AMERICAN SUZUKI MOTOR CORPORATION

Subject: Recall No. 07V-362

4 - STROKE
GS/GSX/GSX-R BULLETIN NO. 172
DATE: 8/16/2007

**SAFETY RECALL CAMPAIGN #2098
ALL 2007 GSX-R1000K7 MODELS
IDLE SPEED CONTROL VALVE REPLACEMENT**

Upper seat rail plate

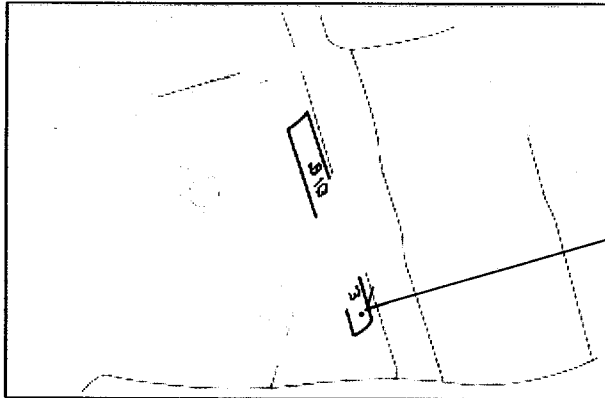
5. Install the air cleaner box in reverse order of removal. (Refer to Service Manual, Page 5-14)
6. Lower the fuel tank. (Refer to Service Manual, Page 5-3)
7. Remove the upper seat rail plate.
Disconnect and remove the ECM. (Figure 1)

8. Install the new ECM in reverse order of removal.

Apply thread lock to the upper plate mounting bolts when reinstalling the upper seat rail plate.
